MODIFIED LOOP OSCILLATOR BOARD [PTOS110AOX] ± 5kHz

DRAWN BY Rick Jackson Euro Radio Co		
File	CYBERNET PTM6121D4X AMFMSSB PART 2	
Size	Document Number PTM6121D4X_SWITCHING_OFFSET_OSC.SCH	
Date	Wednesday, October 22, 2008	Sheet 2 of 2

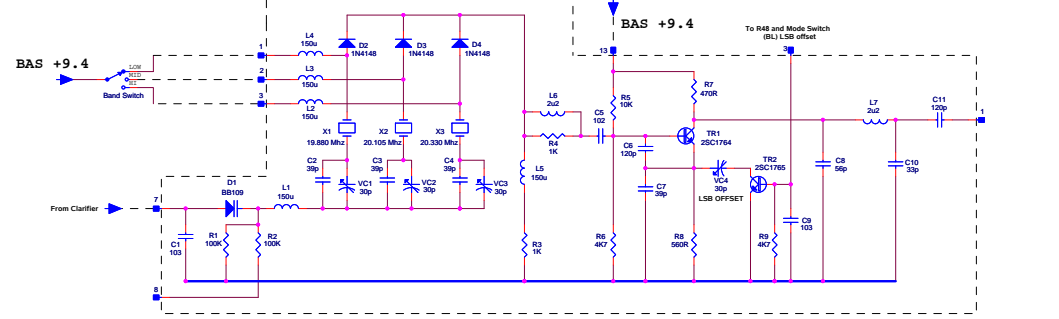
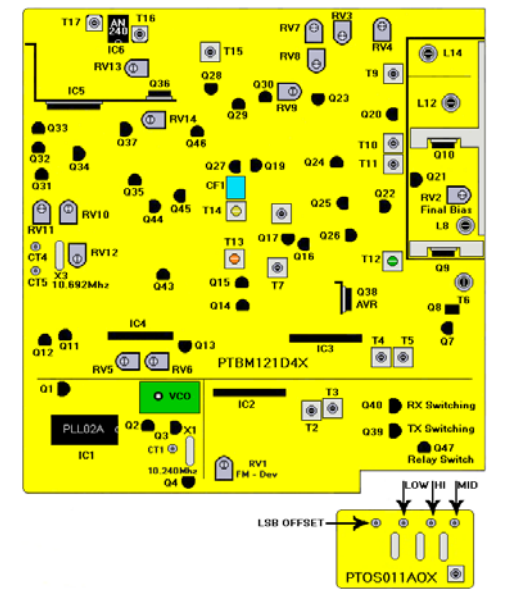
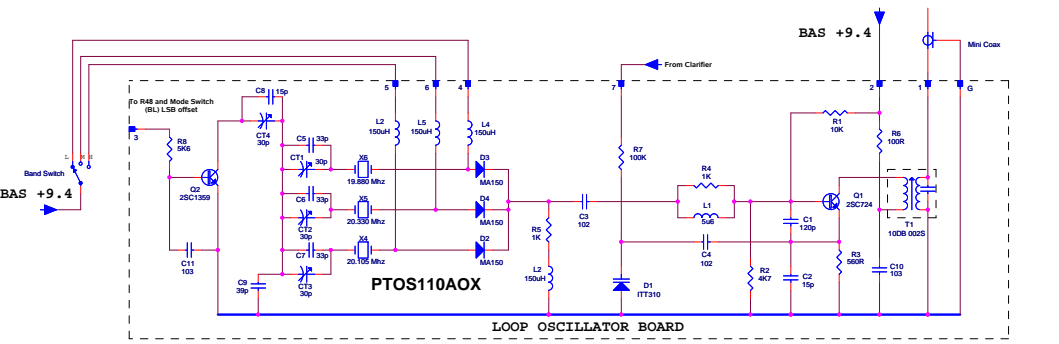
SSB TX Audio
 All Cybernet 121D4X boards suffer with distorted 'gritty' sounding audio on SSB. This was caused by a low bias in the RF output stage, which caused the outgoing signal to distort. As a transistor requires a minimum of around 0.6 volts to conduct, signals below this level are clipped unless the transistor is biased to conduction with a constant dc current.

SSB for TX Audio
 The cure for this problem is to increase the bias. As the bias adjustment (RV2) will not usually take the bias high enough, a resistor will need to be changed.
 1. Replace R44 10 Ohm bias resistor with an 18 Ohm.
 2. Set mode to USB, connect DC milliammeter between Q10 emitter and ground and adjust RV2 for 50mA.
